## Application for Works Approval

**Works Approval Number** W6502/2021/1

**Applicant** Northern Star (HBJ) Pty Ltd

**Premises** Jubilee Gold Mine

Figure 3 Selected standing water level trends from 2019-2021

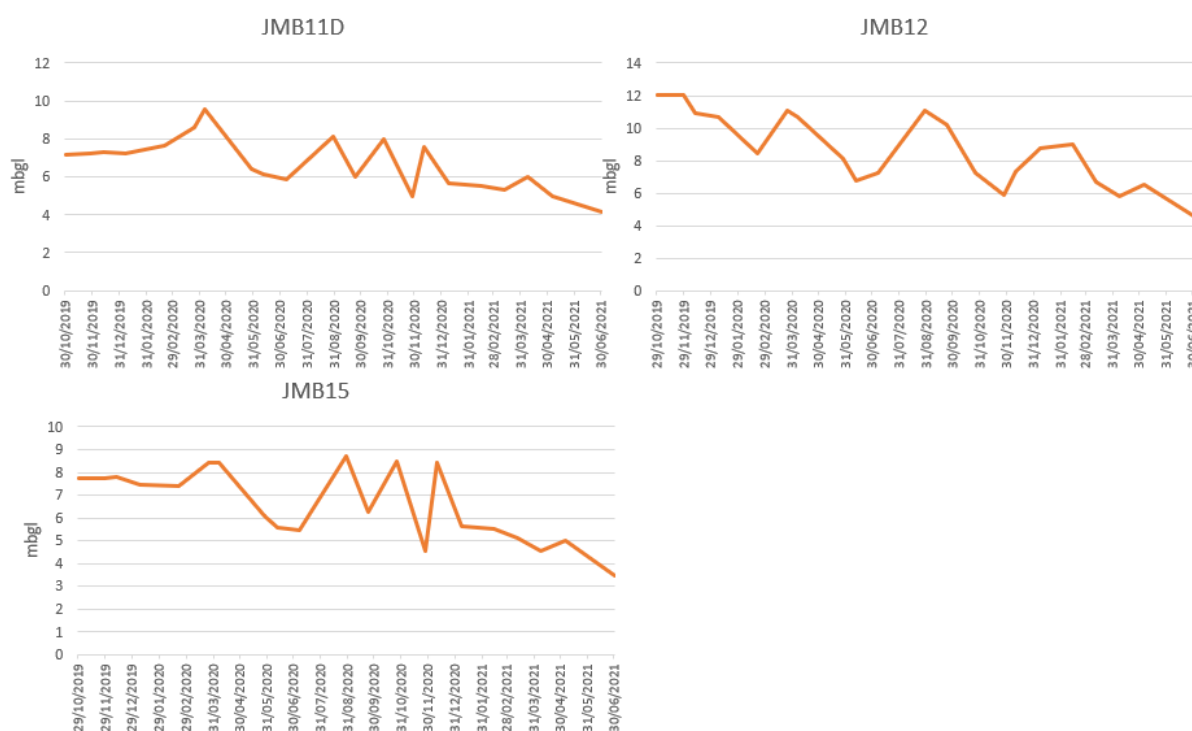
Several exceedances of the standing water level have been reported to the department in 2021 (refer to section 2.2). A review of the standing water levels measures in all monitoring bores from 2019 to July 2021, indicated a steady increase of water levels (selected groundwater level trends in Figure 3). Deposition of additional tailings after the proposed embankment raise will increase the already occurring seepage and rising groundwater level. Currently, three monitoring bores (JMB16, JMB17 and JMB19) are equipped with pumps and act as seepage recovery bores. The applicant submitted a Groundwater study (Coffey, 2020) supporting the works approval application. In this report, the migration of cyanide through seepage to existing monitoring bores has been identified. Total cyanide concentrations up to 1.85 mg/L were detected in monitoring bores surrounding TSF3A/3B. Total cyanide is currently not required to be monitored under licence L5108/1988/13.

Multiple exceedances of the groundwater level (4 mbgl) as set out in licence L5108/1988/13 have been recorded by the department in 2021. The Groundwater study (Coffey, 2020) was based on groundwater monitoring data from 2017 to 2020, where groundwater levels were measured between 5 to 30 m. In the report, additional seepage recovery bores were recommended if the capacity of current seepage recovery wells is exceeded. Based on the already occurring exceedances in 2021, the deposition of additional tailings into TSF3A/3B after the embankment raise will result in more seepage.

Additional seepage recovery bores are required to manage the current groundwater level and mitigate potential impacts from groundwater mounding and contaminant movement from tailings seepage. As part of the Environmental Compliance Report required in the works approval, justification for chosen location and number of seepage recovery bores needs to be provided and has been included as a regulatory control.
